Planning App Ref:	PL/2026/02520
Service Ref:	Drainage
Date:	11/05/2026

Proposed Change of Use to Create 2no. Dwellings.

Unit 5 & 6 Church Farm, Bath Road Shaw, Melksham, SN12 8EF

Figure 1: EA RoFSW extents

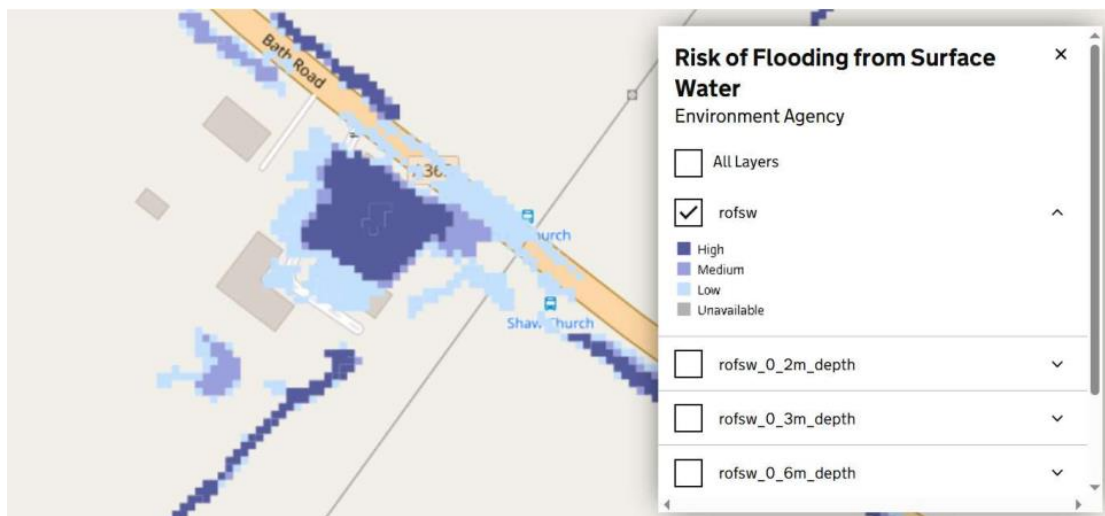
The predicted RoFSW flood depths show a modelled flood depth of 0.2m and 0.3m within the site. The next assessed flood depth is 0.6m in which there is no RoFSW shown within the site. The building area to the north of units 5 -6 would have a depth of water adjacent to the building should RoFSW depths exceed 0.2m depth. However, this water depth would not affect the units due to the FFL being higher than that of the predicted RoFSW depths.
